# Introduction of CSR Rule Change

**(ii)** Oshima Shipbuilding Co.,Ltd.

Introduction of Rule Change Proposal 2018 (RCP2018)

#### 1. The clarification of sniped stiffener for BC & OT

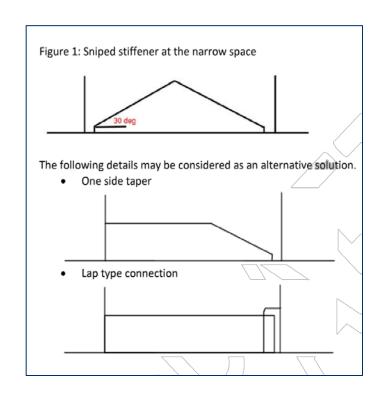
- The original rules require that the sniped stiffeners are not to be more than 30degree.
- The original rules require the stiffener to be triangle at the narrow space as shown in left figure.
- RCP2018 consider alternative arrangement for the snipped stiffeners at the narrow space as shown in right figure.

### Brackets at the heel of horizontal stringer;

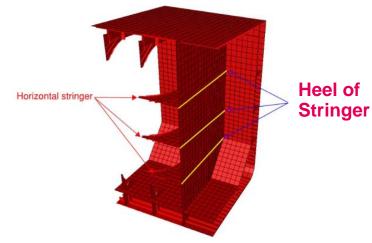
- Original Rule
   Fine mesh analysis is no required.
- RCP2018
   Fine mesh analysis is required.

These brackets are usually made for the fine mesh analysis voluntarily by the Shipbuilder.

Although the shape of bracket may need to be improved by results of fine mesh analysis, the impact on hull weight is small.

#### 3. Full penetration welding at corners of hatchway for BC

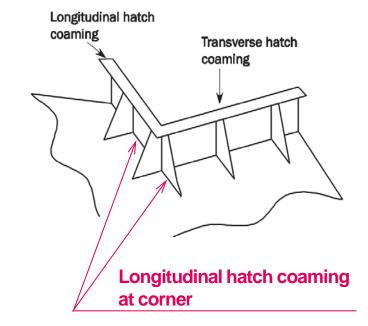
The extent of full penetration welding of the connection of the longitudinal hatch coaming to deck plating at corners of hatchway;

- Original Rule
   At corners of hatchways for 15% of the hatch length.
- RCP2018
   Longitudinal hatch coaming at corners of hatchways on a length of 15% of the hatch coaming height.

The extent of full penetration welding is reduced.

#### 2.4.5 Location required for full penetration welding

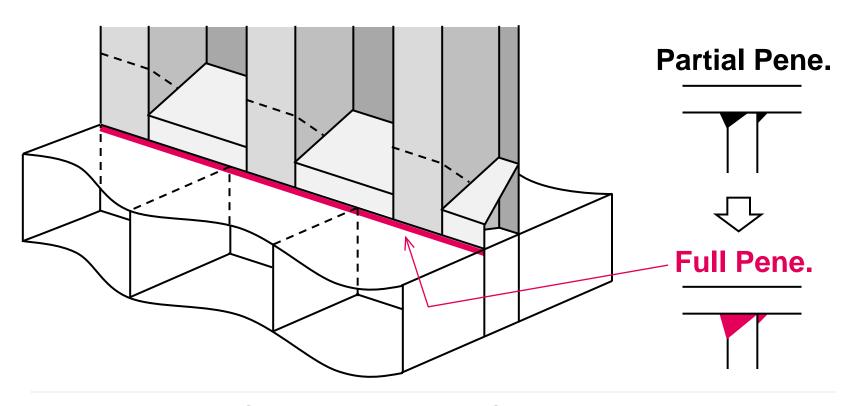
Full penetration welds are to be used in the following locations and elsewhere as required by the rules, see Figure 3:

- a) Floors to hopper/inner bottom plating in way of radiused hopper knuckle.
- b) Radiused hatch coaming plate at corners to deck.
- c) Connection of vertical corrugated bulkhead to the lower hopper plate and to the inner bottom plate within the cargo hold region, when the vertical corrugated bulkhead is arranged without a lower stool.

- d) Connection of structural elements in the double bottom in line with corrugated bulkhead flanges to the inner bottom plate, when the vertical corrugated bulkhead is arranged without a lower stool.

- e) Connection of vertical corrugated bulkhead to the lower hopper plate, and connection of structural elements in the lower hopper area in line with corrugated bulkhead flanges to the lower hopper plate, where connections are clear of lower stools.

- fd) Connection of vertical corrugated bulkhead to top plating of lower stool.
- g) Corrugated bulkhead lower stool side plating to lower stool top plate.

- h) Corrugated bulkhead lower stool side plating to inner bottom.
- i) Connection of structural elements in double bottom to the inner bottom plate in holds intended for the carriage of liquid at sea with a distance of 450300 mm from the side plating of the lower stool, see Figure 3a.

#### 2.4.5 Location required for full penetration welding

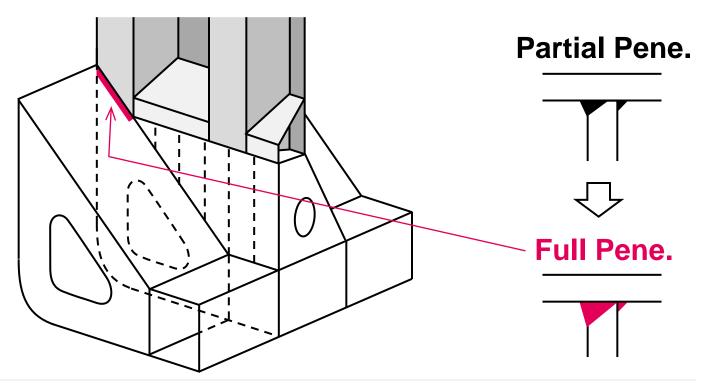
d) Connection of structural elements in the double bottom in line with corrugated bulkhead flanges to the inner bottom plate, when the vertical corrugated bulkhead is arranged without a lower stool.

e) Connection of vertical corrugated bulkhead to the lower hopper plate, and connection of structural elements in the lower hopper area in line with corrugated bulkhead flanges to the lower hopper plate, where connections are clear of lower stools.

#### 2.4.5 Location required for hull penetration welding

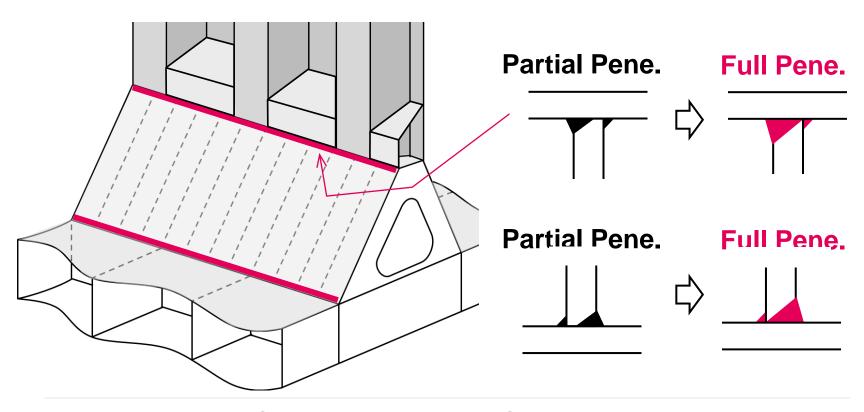
g) Corrugated bulkhead lower stool side plating to lower stool top plate.

h) Corrugated bulkhead lower stool side plating to inner bottom.

#### 2.4.5 Location required for hull penetration welding

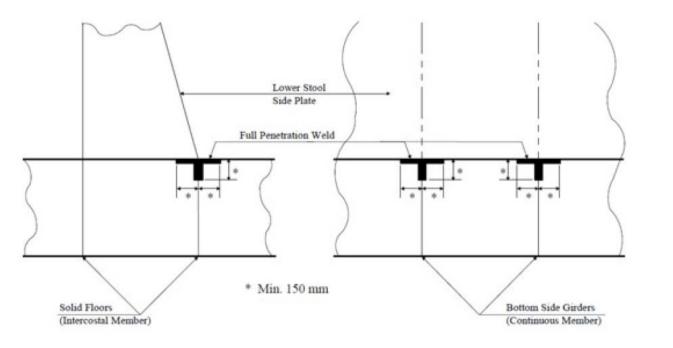
i) Connection of structural elements in double bottom to the inner bottom plate in holds intended for the carriage of liquid at sea with a distance of 150300 mm from the side plating of the lower stool, see Figure 3a.

Min. 150mm

Min. 300mm

#### Estimated vessel;

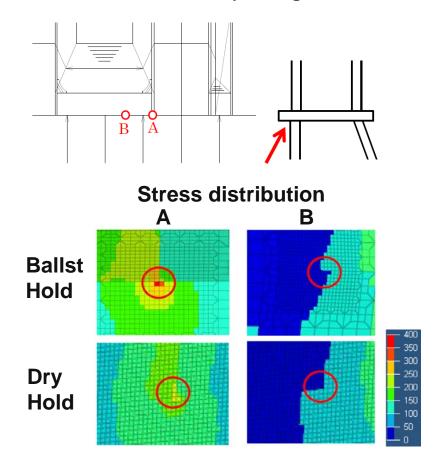
Post Panamax BC, 7 cargo holds, 6 bulkheads

|            | Original     | Revised      |
| Deep Pene. | <b>490</b> m | _\_          |
| Full Pene. | <b>255</b> m | <b>745</b> m |

Welding length will triple from the original rules.
